AURIX™ TC37x errata sheet

Marking/Step: (E)ES-AA, AA

10525AERRA

Figure 1 Message buffer transfer from Message RAM to OBF

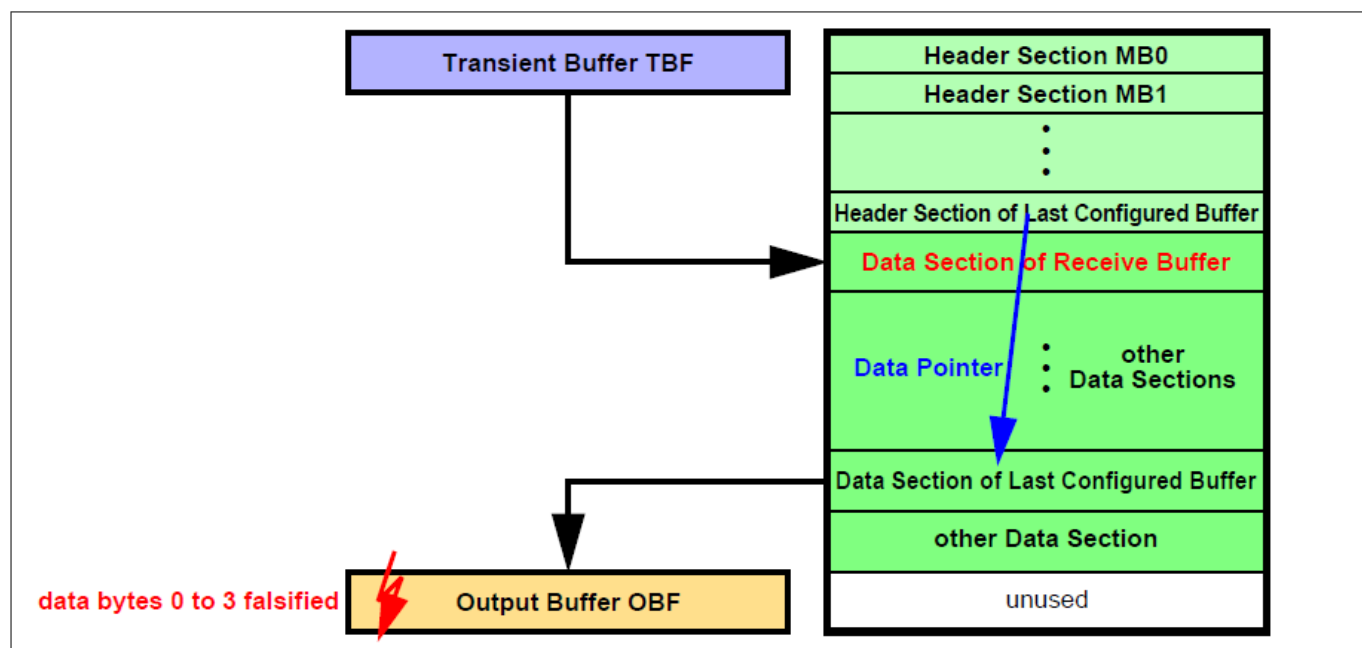
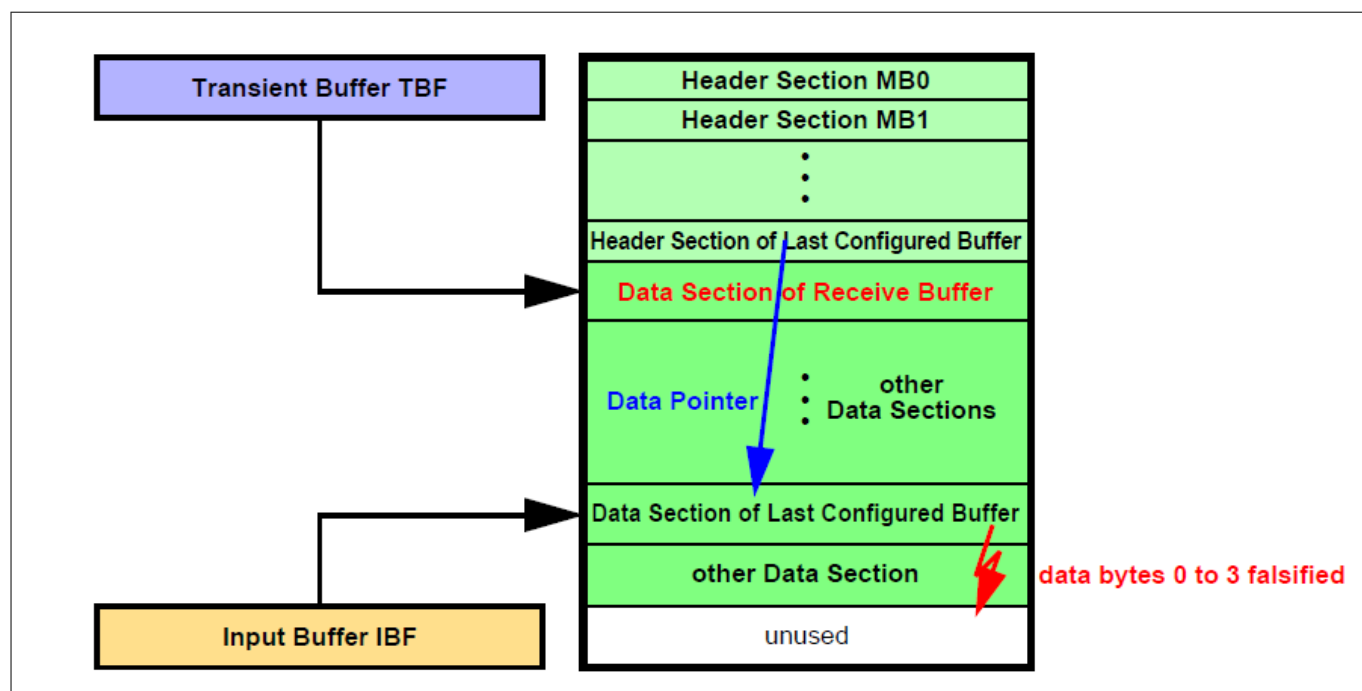
When the message buffer has its payload configured to maximum length (PLC = 127), the OBF word on address 00h (payload data bytes 0 to 3) is overwritten with unexpected data at the end of the transfer.

After the Data Section of the selected message buffer in the Message RAM has been written, one additional write access overwrites the following word in the Message RAM which might be the first word of the next Data Section.

Ensure that the Data Section directly following the Header Partition is assigned to a transmit buffer.

Figure 3 Message RAM configurations

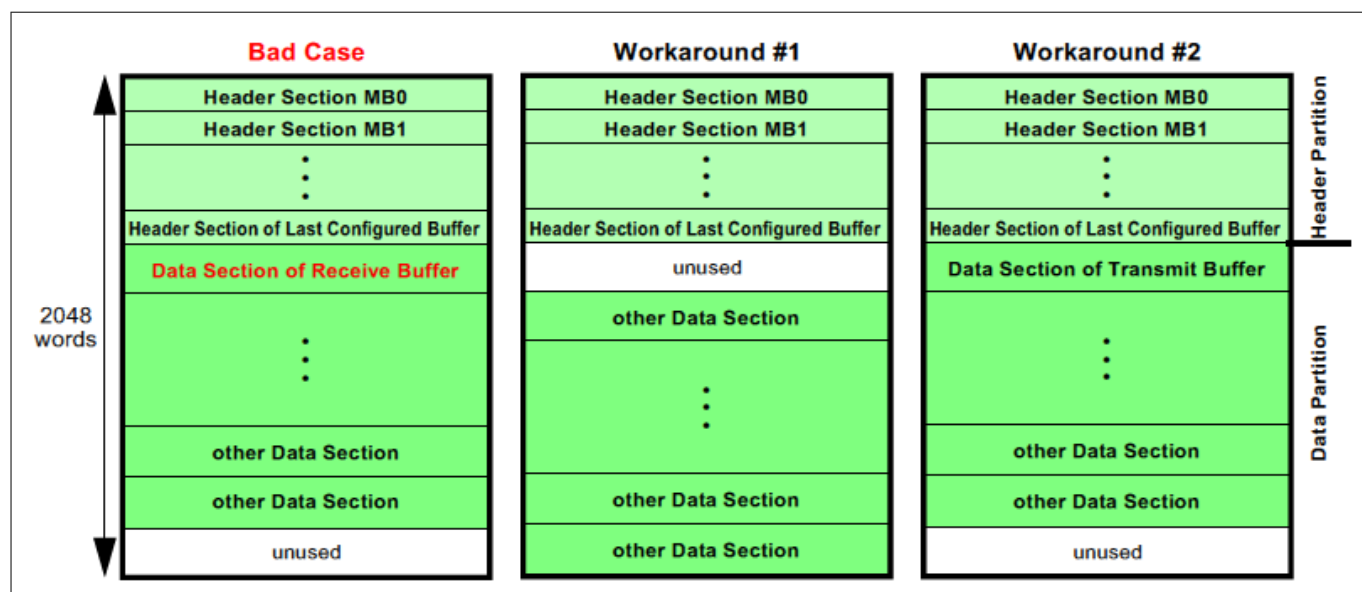
The erratum is limited to the case when (see [Figure 3](#) “Bad Case”):

- a) When a message is transferred from the Last Configured Buffer in the Message RAM to the OBF and PLC = 127 it may happen, that at the end of the transfer the OBF word on address 00h (payload data bytes 0 to 3) is overwritten with unexpected data (see [Figure 1](#))
- b) When a message is transferred from IBF to the Last Configured Buffer in the Message RAM, it may happen, that at the end of the transfer of the Data Section one additional write access overwrites the following word, which may be the first word of another message's Data Section in the Message RAM (see [Figure 2](#))

Figure 6 Critical MCS AEI master scenario

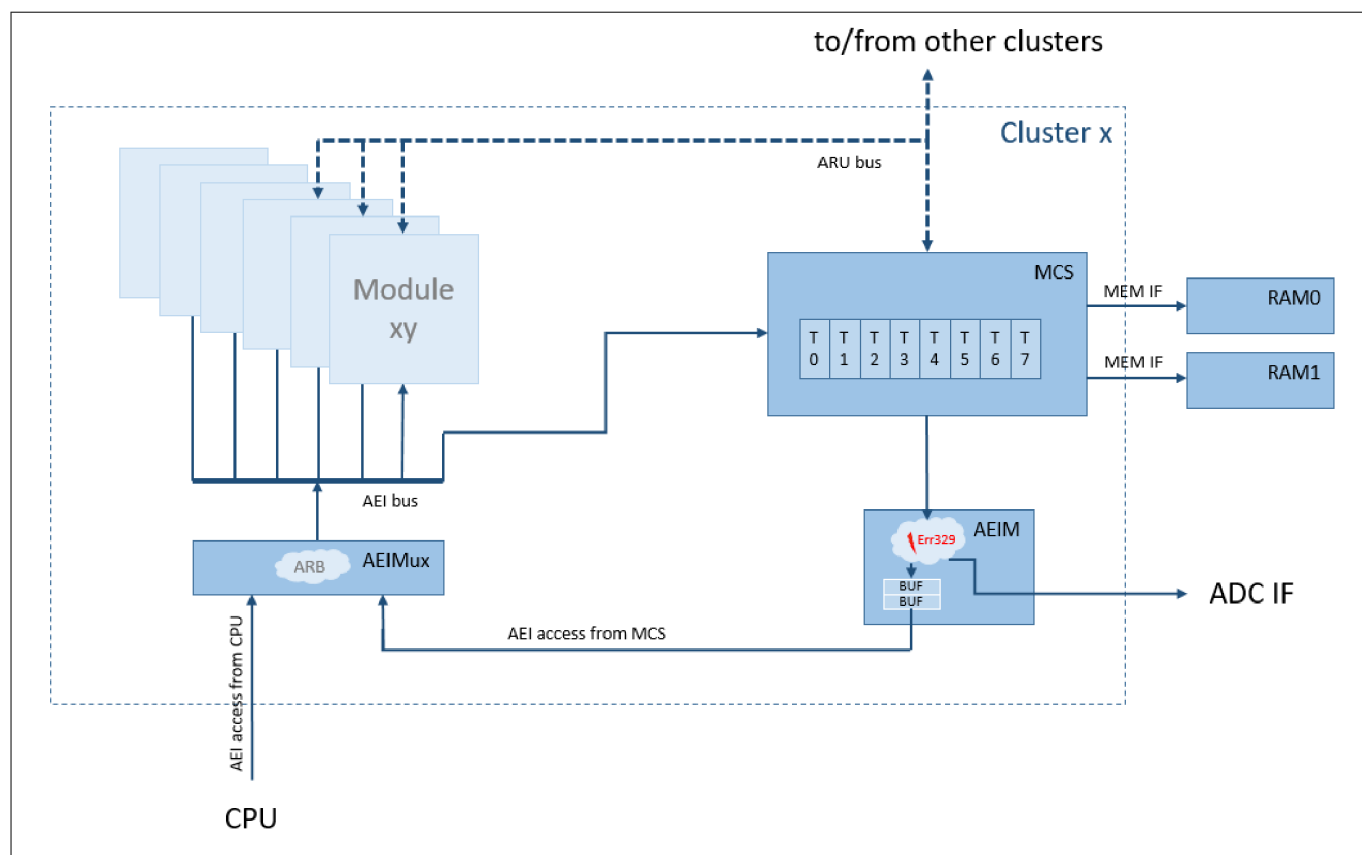
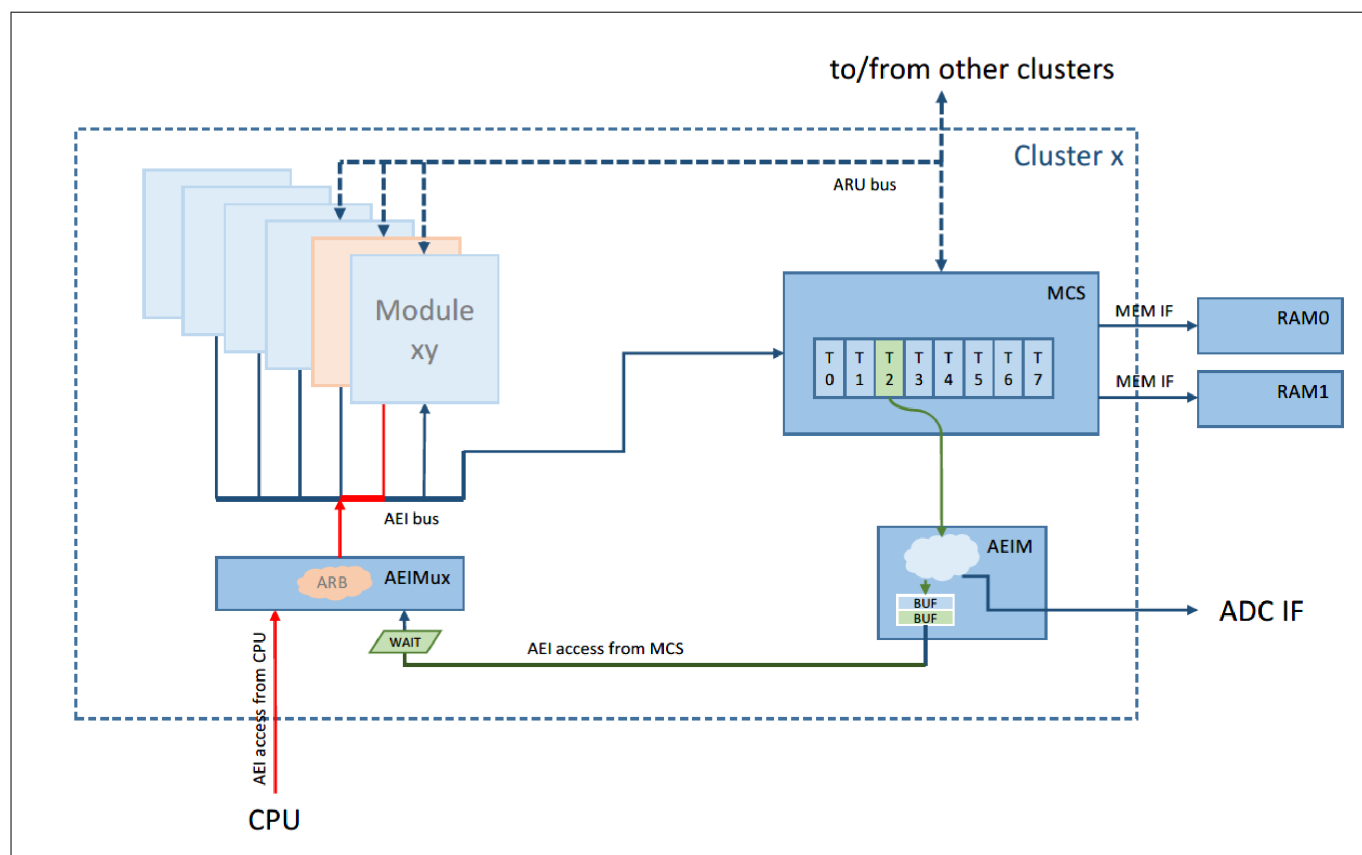
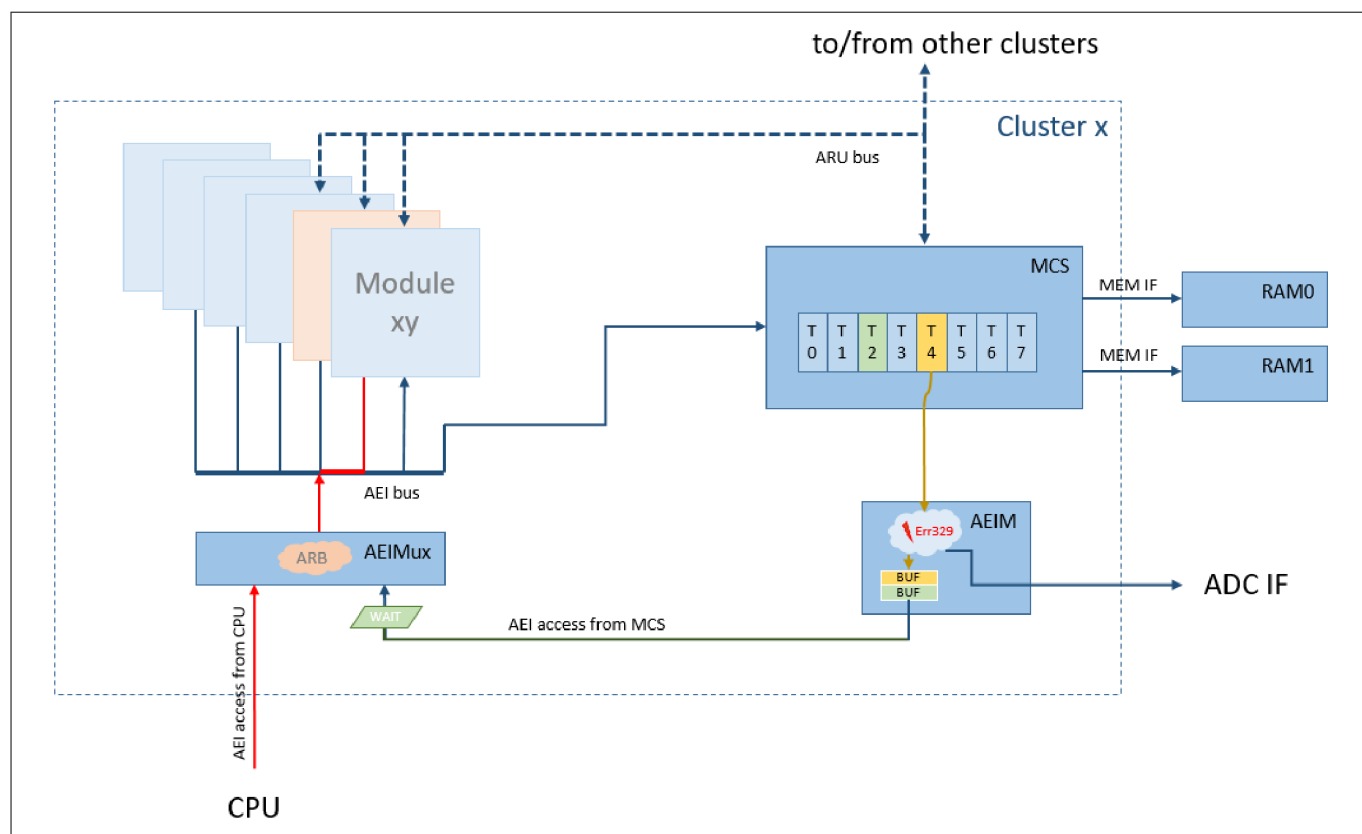
Problem GTM_AI.329 is related to a potential incorrect handling of MCS access requests to the AEI bus at the AEIM entry stage in case that one AEIM buffer is already filled. If in such a case a new access request from MCS enters the AEIM logic during a very specific time window (related to progress on the AEI bus), the AEIM logic might signalize incorrect parameters back to MCS that could result in incorrect data, the loss of data or a repetitive execution of MCS accesses to AEI.

Figure 5 shows an uncritical traffic situation. Here an access of a MCS thread to the AEI bus (green access path) is temporary delayed due to an ongoing AEI bus access from the CPU (red access path). The MCS access to the AEI bus will be safely buffered at the AEIM (green buffer). As soon as the CPU access to the AEI bus completes, the buffered AEI bus access from MCS will be executed.

In [Figure 6](#), a potential risk for the occurrence of problem GTM_AI.329 is illustrated. Here the first buffer of the AEIM (green) is still waiting for the access to the AEI bus while a second AEI bus access from MCS arrives at the AEIM (yellow access path). Under certain, but for the user unpredictable timing conditions, this second AEI bus access arriving at the AEIM can trigger the misbehavior described in problem GTM_AI.329.

The workarounds described in the 'Workaround' section will ensure that not more than one AEIM buffer will be filled and therefore the occurrence of problem GTM_AI.329 is avoided. All workarounds have been tested and proven correct.

To ensure that a correct execution of MCS channel code is not influenced by certain traffic scenarios on the MCS AEI/ADC bus master interface, only proven usage scenarios are allowed for MCS to AEI/ADC communication. The most common usage scenarios tested to be safe include:

Figure 7 MCS token mechanism

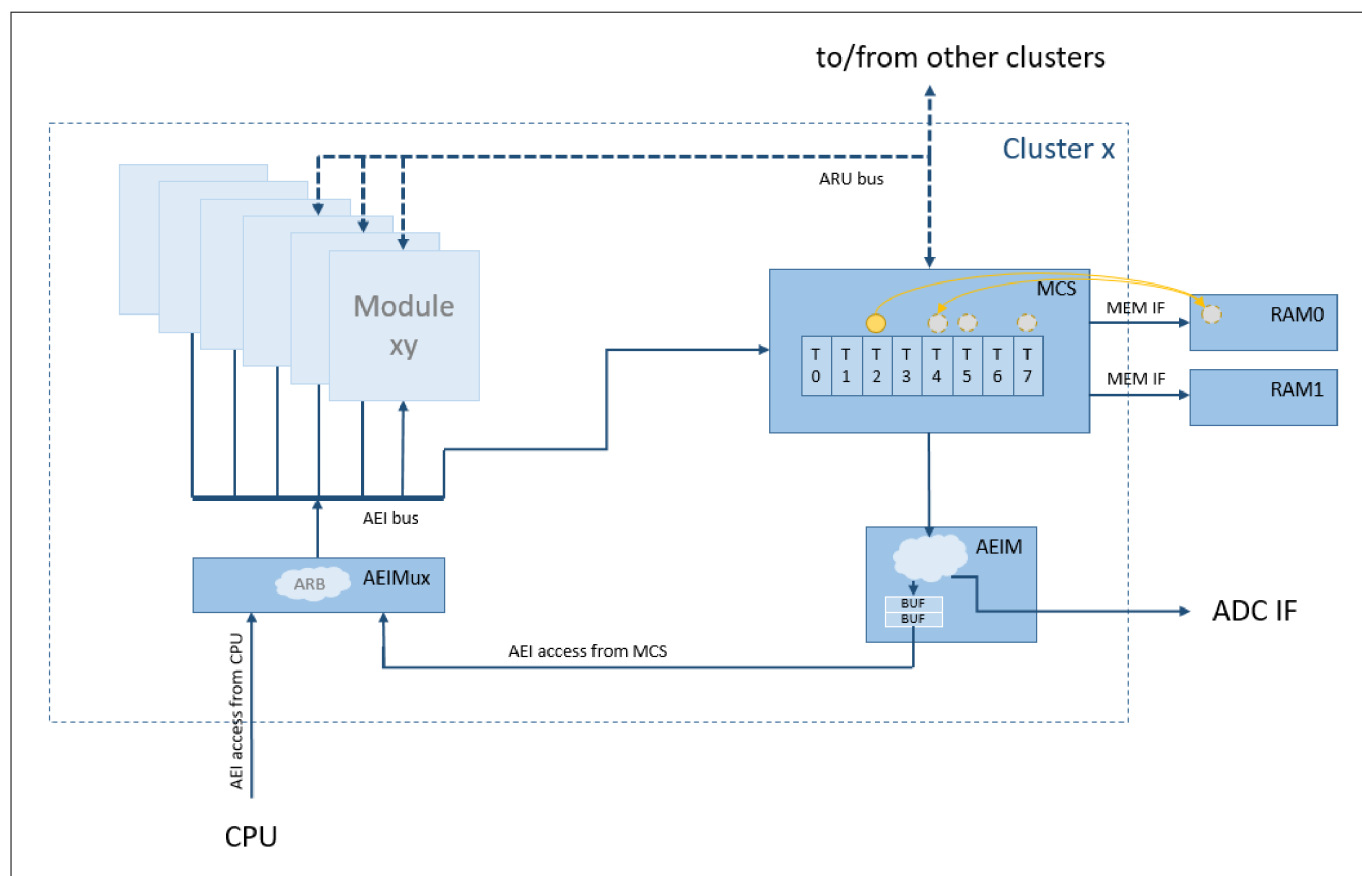
In case multiple MCS channels want to use the AEI master port for AEI or ADC communication, establish a mechanism that ensures that only one channel uses the AEI master at a time (e.g. exchange a token between channels or use trigger registers to hand over the AEI master port ownership between MCS channels).

An application note (AN020 – MCS Mutex implementation) describing a token exchange mechanism between MCS threads is available at Bosch. Such a token mechanism allows multiple MCS threads to safely access the AEI bus system by exchanging an AEI bus access token via MCS memory.

Figure 11 Interrupt Level vs. Pulse-Notify mode - Corner Case Example

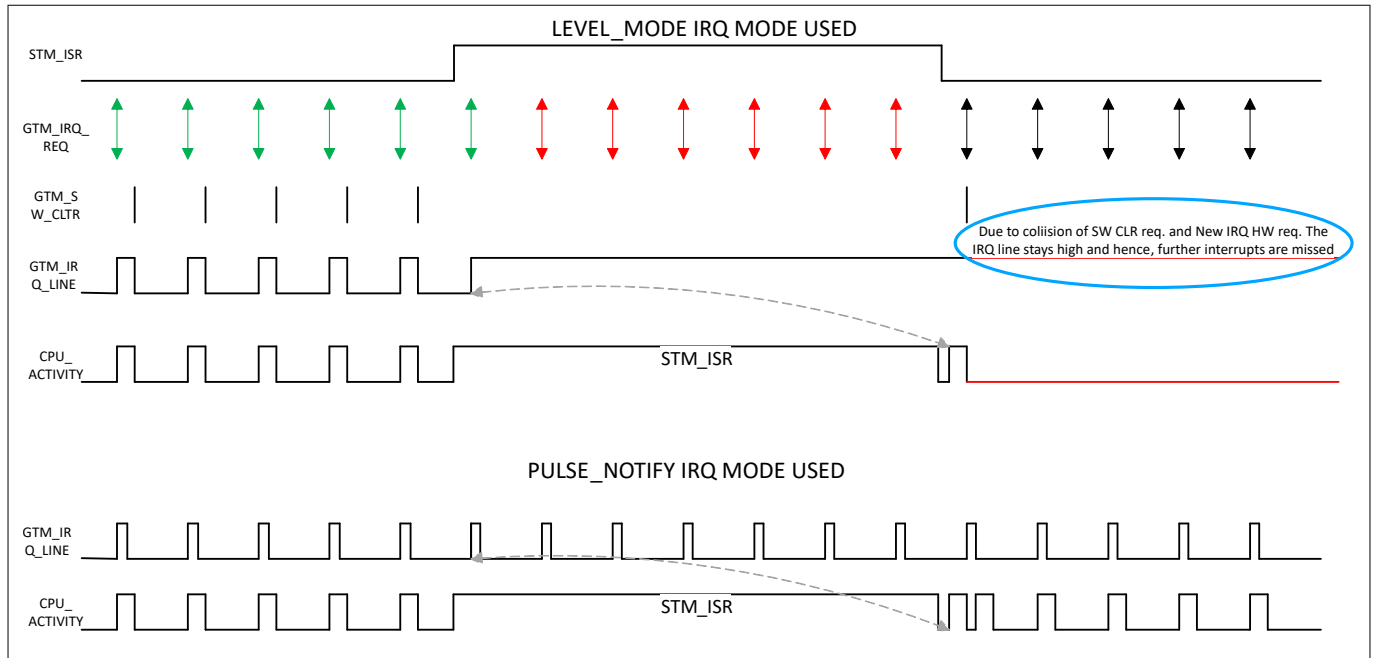
interrupt and clear events), GTM_IRQ_XXX is not cleared and remains high. As a consequence, the IR observes no transition on GTM_IRQ_XX. Thus, any forthcoming interrupt events in this scenario are lost as there is no chance to release the CPU IRQ when a collision happens as shown in Figure below.

If Pulse-Notify mode is selected, every internal trigger will be forwarded to the IR, irrespective of the time of occurrence and the clear event, as the pulse-notify leads to set and reset of GTM_IRQ_XXX as compared to only setting of the GTM_IRQ_XXX line in Level mode.

Figure 12 Timing of LVDS TX interface command sending in relation to IRQ.IFCFS

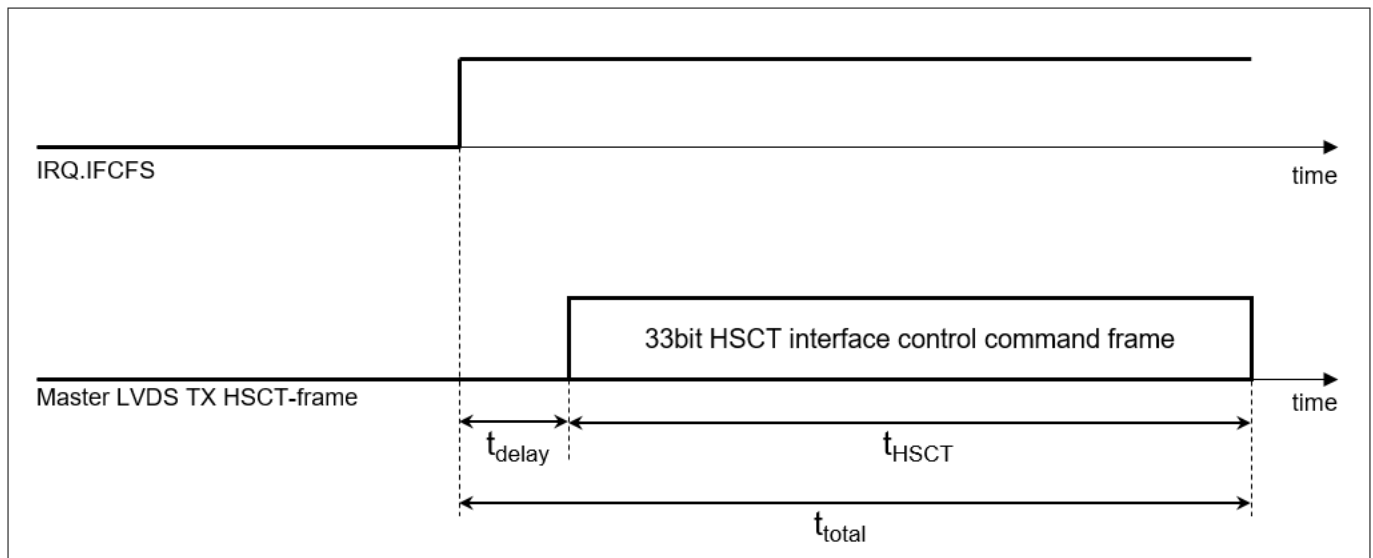
the user might falsely assume that also the actual sending on the LVDS TX port has already occurred once the IRQ.IFCFS flag is set, which is not true.

Instead the timing shown in the following figure applies.

Figure 13 Package Outlines LQFP-176 for TC37x

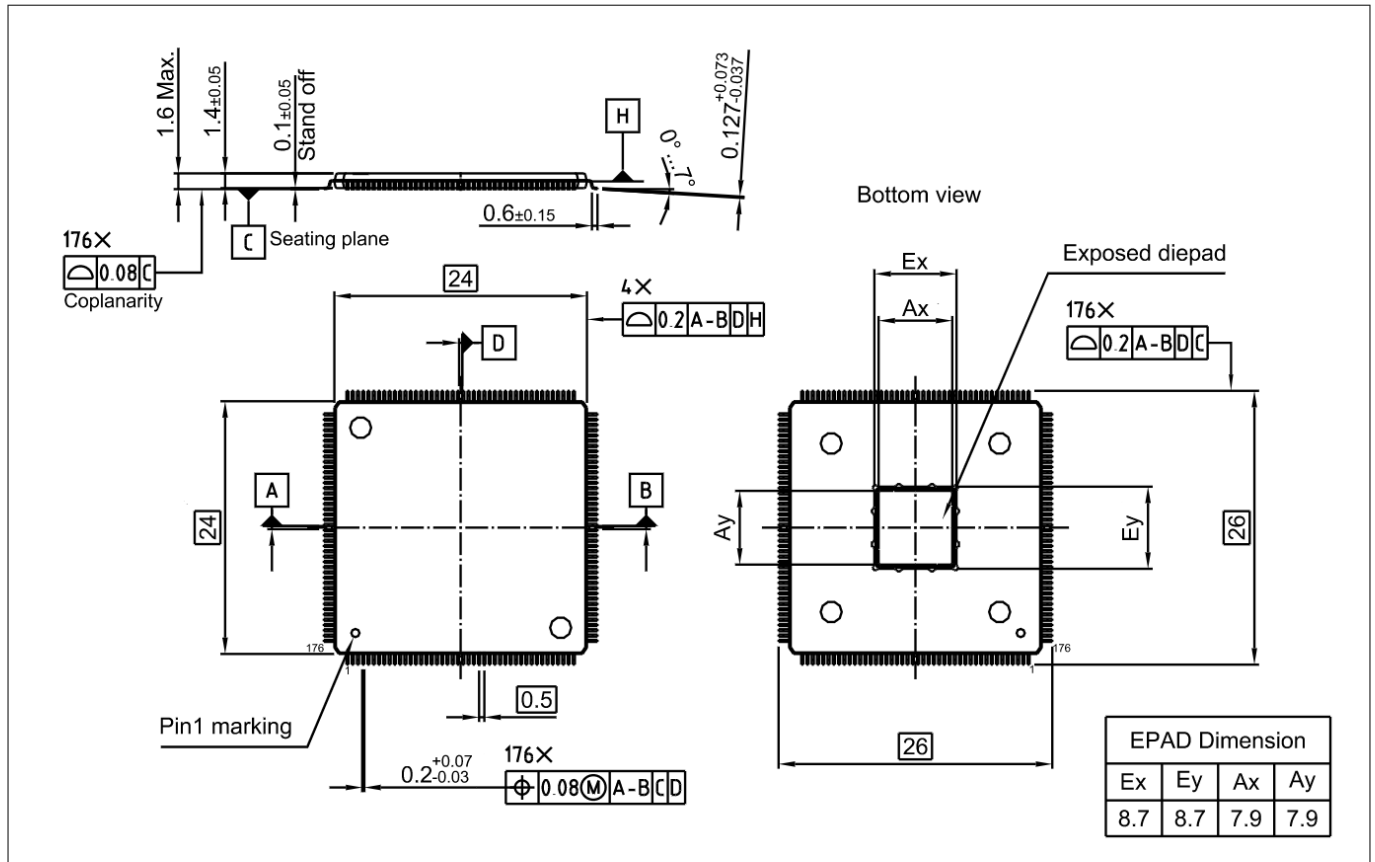
This information shall substitute the corresponding information in the TC37x AA-step Data Sheet V1.1.

Note: For the exposed diepad of the LQFP-176 package of the TC37x, structural corner protrusions have to be considered for purposes of system design and integration with a maximum boundary of 9.4 mm.
